PENNSYLVANIA PUBLIC UTILITY COMMISSION

STAFF'S STATEMENT #1

A-00111016
C-00913256
A-00111016
6/12/97
Harrisburg

TESTIMONY OF DAVID A. OLIVER

PUC STAFF EXHIBIT #4

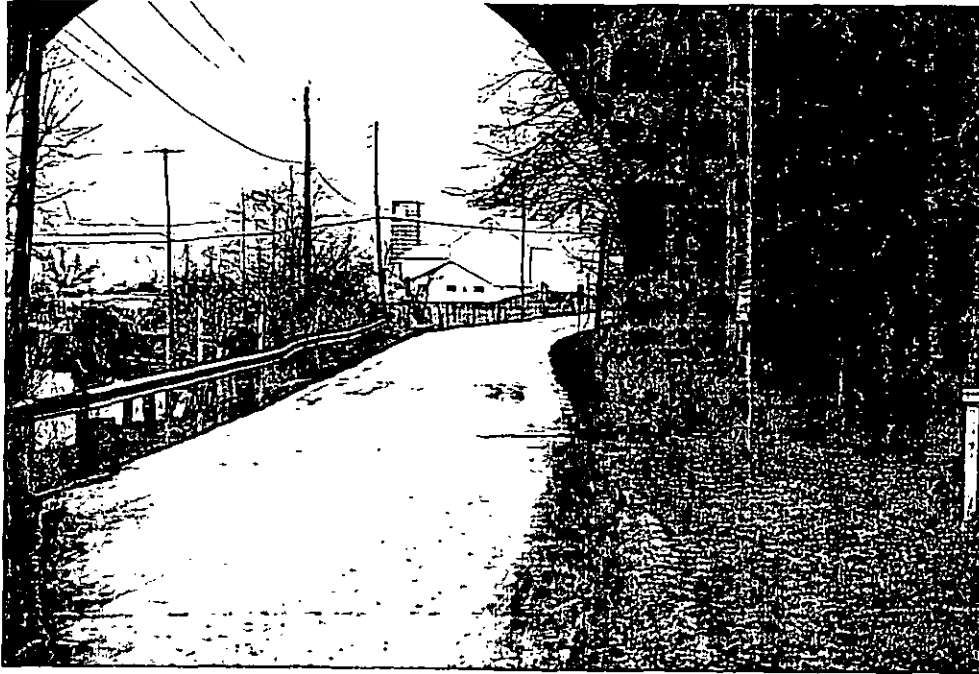
7 A: Exhibit No. 4 is the southerly approach to the bridge
8 looking north. Note that the bridge is one lane only.
9 Exhibit No. 5 is the northerly approach to the bridge
10 looking south. The sign to the right of the bridge
11 indicates a ten ton weight limit.

2 A: According to current Department of Transportation design
3 criteria, the bridge has substandard pavement width, and
4 shoulder width. In addition, there is no speed limit posted
5 and vehicular traffic is limited to a maximum allowable load
6 of ten tons.

18 A: Remove the existing bridge and place the roadway on earth
19 embankment if the continuation of the roadway is deemed
20 necessary by Sadsbury Township.

20 A: Add "Bridge" sign to existing weight limit sign, speed limit
21 signs, advance one land bridge sign and guide rail on each
22 approach to the bridge.
23

PUC STAFF EXHIBIT #15

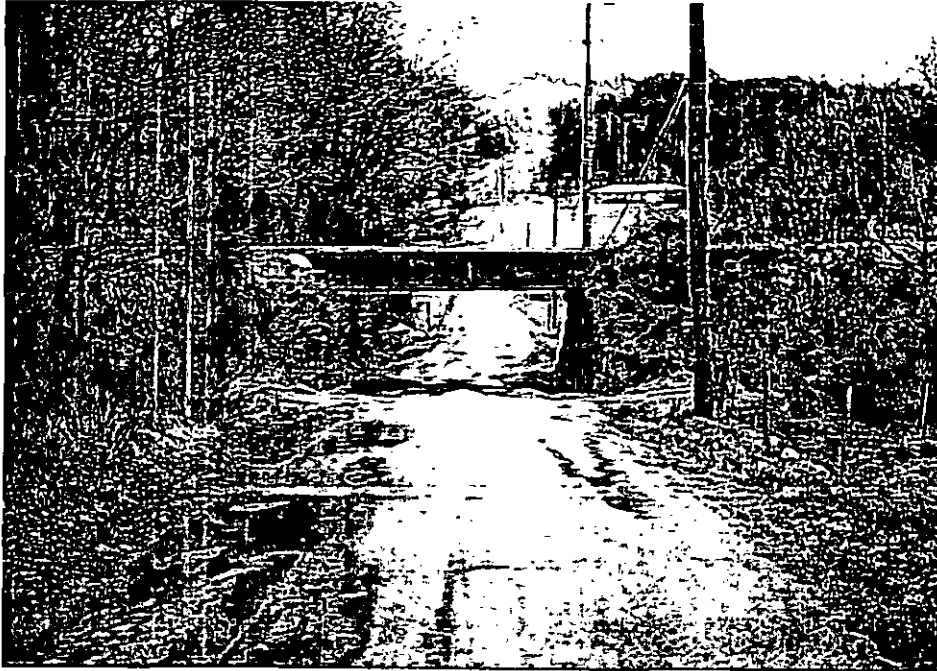
7 A: Exhibit No. 15 is the northerly approach roadway looking
8 south. Note the proximity of the abutments to the roadway
9 and the lack of vertical clearance between the bottom of the
10 girder and the top of the roadway. Also note that the
11 ballast on top of the bridge is above the top of the girder.
12 Exhibit No. 16 is the southerly approach roadway looking
13 north.

2 A: According to Department of Transportation design criteria,
3 the pavement width, shoulder width and vertical clearance
4 are substandard. I observed that the bottom flanges on one
5 of the girders was bent back. This probably is a result of
6 a vehicle hitting the underside of the bridge.

10 A: Remove the structure and grade back the embankment to a 2:1
11 slope.

10 A: Post vertical clearance signs, post speed limit signs,
11 construct guide rail at the approaches to the bridge, place
12 object markers and place protective fencing on top of the
13 girders. Consideration should also be given to raising the
14 girder superstructure in order to obtain additional vertical
15 clearance.

PUC STAFF EXHIBIT #17

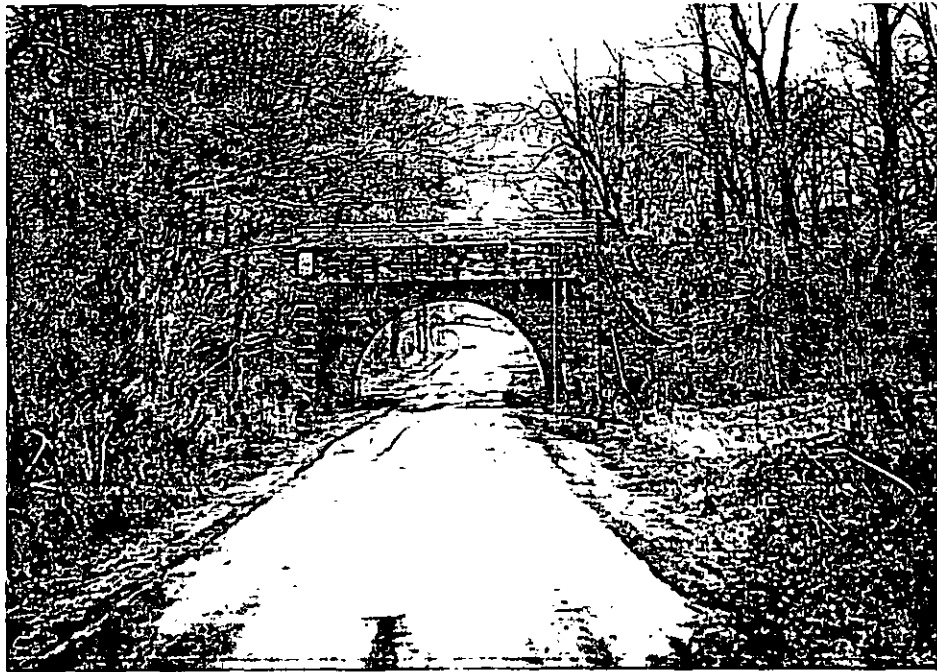
3 A: Exhibit No. 17 is the northerly approach roadway looking
4 south. Note that the proximity of the arch to the side of
5 the roadway. Exhibit No. 18 is the southerly approach
6 roadway looking north. Note the ballast on top of the
7 bridge is higher than the side wall.

18 A: According to Department of Transportation design criteria,
19 the shoulder width and vertical clearance are substandard.

23 A: Remove the structure and grade back the embankment to a 2:1
24 slope.

20 A: Post vertical clearance signs, construct guide rails at the
21 approaches to the bridge, place object markers and place
22 protective fencing on top of the structure.
